**Safety Relevant Issues and Measures:
Khmelnitsky 2 and Rovno 4 NPPs**

Updated Version

**Report to the
Ministry of Environment, Youth and Family
of the Republic of Austria**

Risk Research Report Nr. 14a

Figure 3 Reactor Building with Containment - Plan View (29.00 m Elevation)

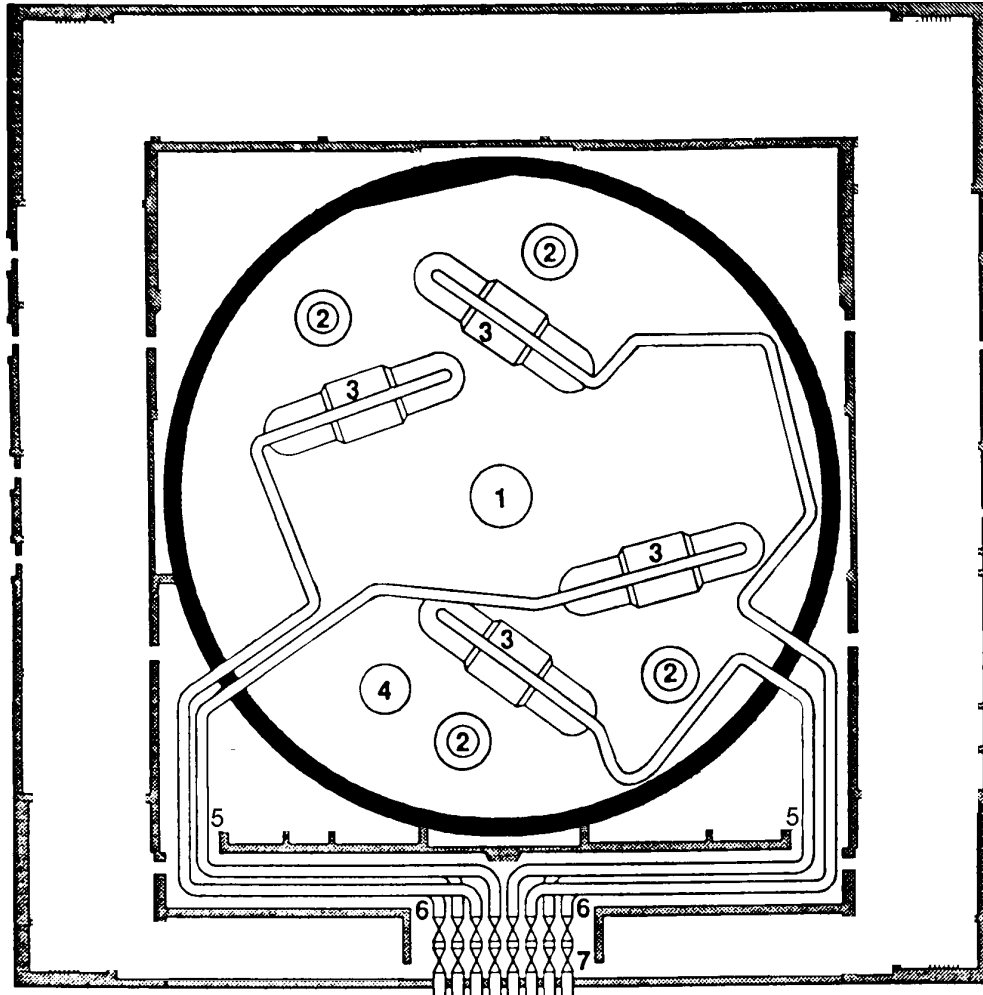
A failure of the highly energized steam lines is a generic problem for all power reactors. For WWER-1000/V-320 reactors the problem is complicated by the closeness of steam lines and feedwater pipes not separated by protective shields on the 28.8 m level between reactor building and machine hall. (See Figure 3)

Figure 4 Reactor Pressure Vessel with Internals

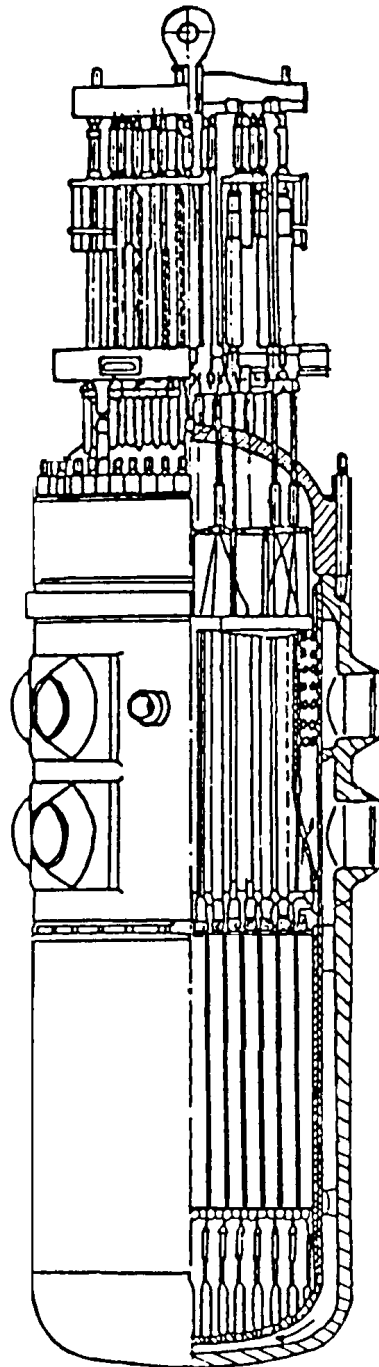
- a relative small downcomer water/steel gap between pressure vessel wall and core periphery region (see Figure 4).
- and a higher Ni concentration in vessel beltline area welds (see Figure 5).

Figure 6 Steam Generator

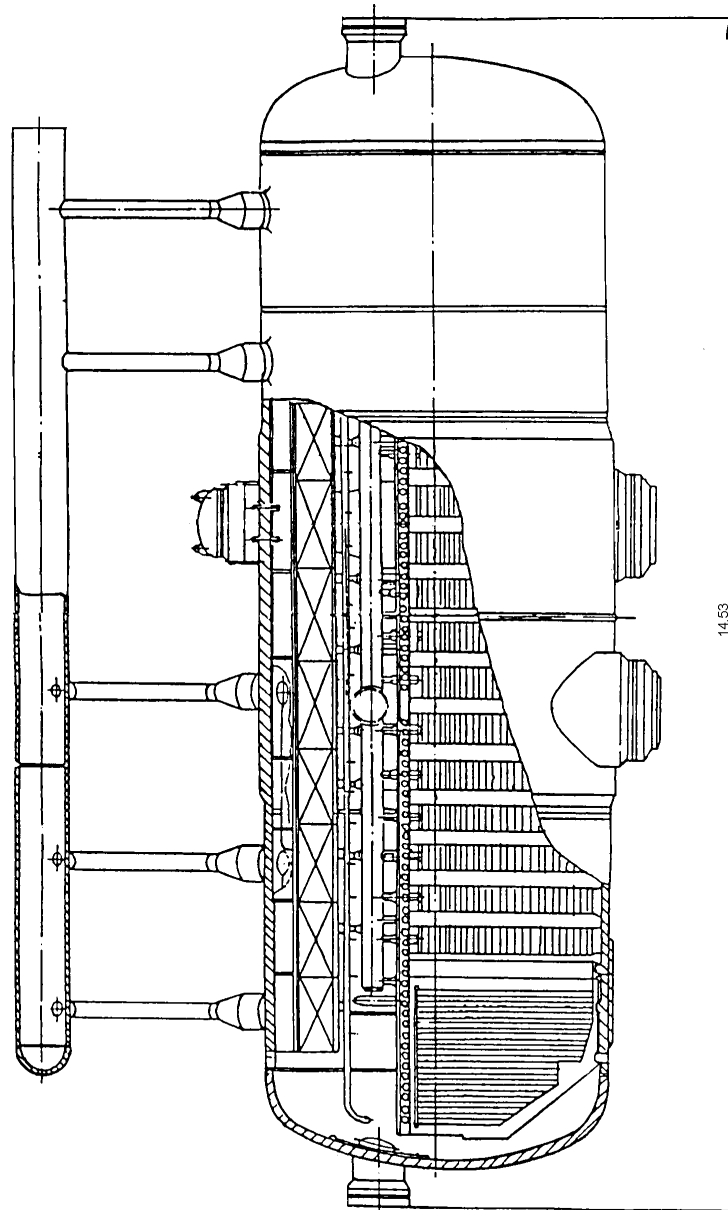
developed (transition to corrosion-proof steel, reduction of the number of heat exchanger pipes in the most intense part of the collectors, perfection of manufacturing technology etc.) and are to a large part implemented in all working units (Atomaudit, 1997). However, it was not possible to verify this information on the basis of related documents.

Unless the above information is confirmed, the improper design of steam generators manufactured for R4 and K2 will probably not allow their operation until the end of the plant design life time.

The steam lines are endangered by the possibility of steam generator collector break and the resulting large primary to secondary leak (see Figure 6). This can lead to radioactive release and to a loss of primary coolant outside the containment. Therefore, greatest attention must be given to this serious safety issue.
